UNITED STATES OF AMERICA  
NUCLEAR REGULATORY COMMISSION

Application of SOUTHERN CALIFORNIA	)	
EDISON COMPANY, <u>ET AL.</u> for a Class 103	)	Docket No. 50-361
License to Acquire, Possess, and Use	)	
a Utilization Facility as Part of	)	Amendment Application
Unit No. 2 of the San Onofre Nuclear	)	No. 101
Generating Station	)

DESCRIPTION AND SAFETY ANALYSIS OF  
PROPOSED CHANGE NUMBER NPF-10/15-346

This is a request to revise Technical Specification 3/4.5.2, "ECCS SYSTEMS -  $T_{avg}$  GREATER THAN OR EQUAL TO 350°F," and its associated Bases B3/4.5.2, "ECCS SYSTEMS -  $T_{avg}$  GREATER THAN OR EQUAL TO 350°F."

SAN ONOFRE UNITS 2 & 3  
 FIGURE 1

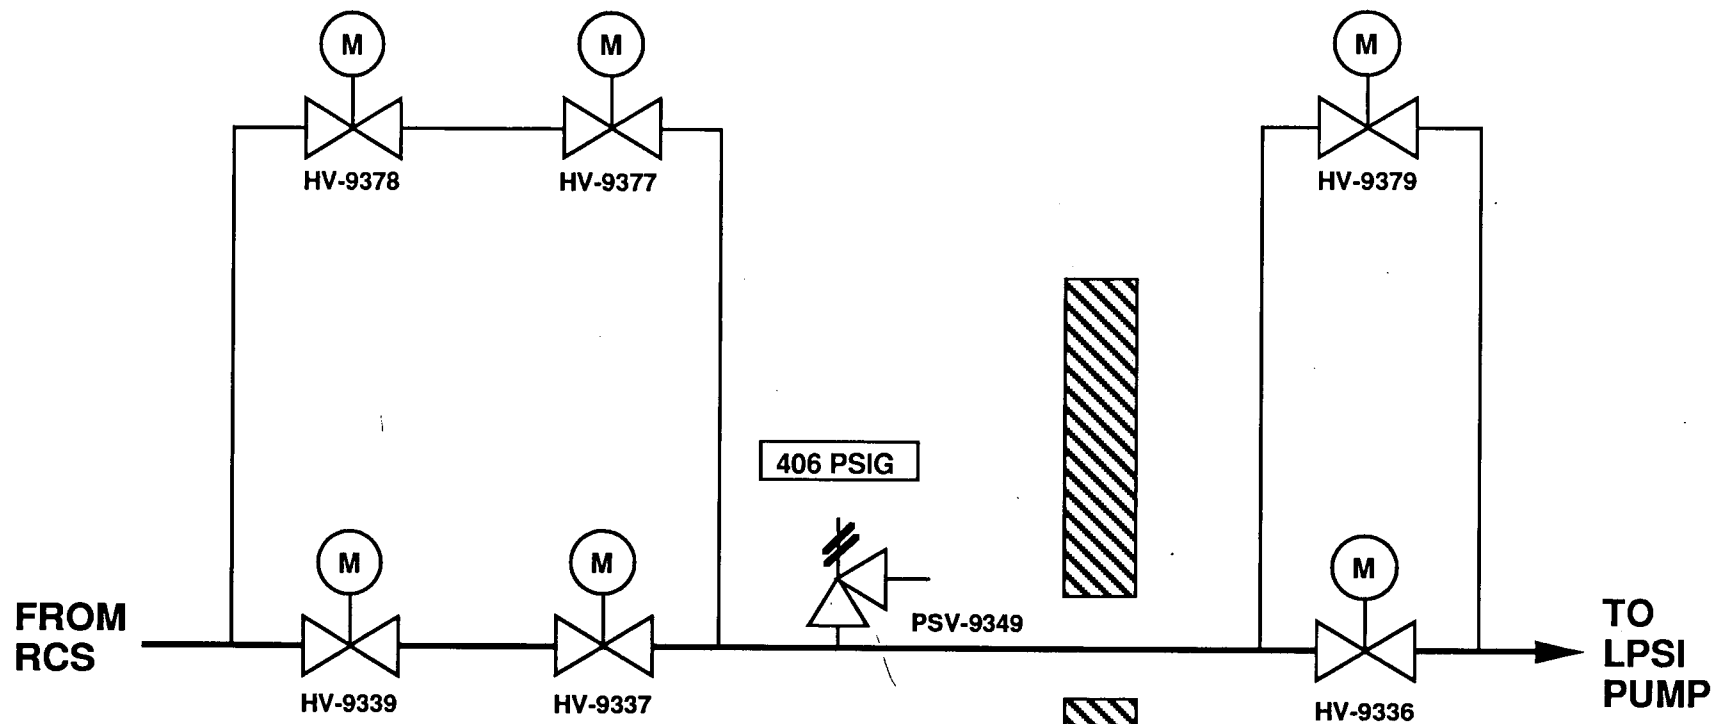
When the SDC system is in use, the SDC system becomes an extension of the Reactor Coolant Pressure Boundary (RCPB). Since a number of pressurization sources exist within or are connected to the high pressure RCS, the low pressure SDC system must be protected against postulated pressurization transients when the systems are connected. To accomplish this, a SDC system relief valve is provided as shown in Figure 1.

The following discussion is provided to identify the scope of the modifications required for San Onofre Units 2 and 3. The configuration of San Onofre Units 2 and 3 is shown in Figure 1. The needed changes to meet the NRC guidelines and the CE Owners Group (CEOG) recommendations are:

- A) Disconnect ACI circuits
- B) Provide independent position indication input for valve position alarm.
- C) Revise UFSAR to commit to alarm testing.
- D) Revise procedures to be consistent with NRC guideline #4.
- E) Delete ACI surveillance technical specification.

SCE, in following the above NRC guidelines and CEOG recommendations, is requesting to remove the ACI. The existing "Pressurizer Pressure Above Setpoint Valve Not Closed" alarm in the control room will be retained with valve position input from a source independent of valve control functions and valve position indication. This alarm is to warn operators if the RCS pressure is 383 psia or greater and any of the SDC suction isolation valves is not fully closed.
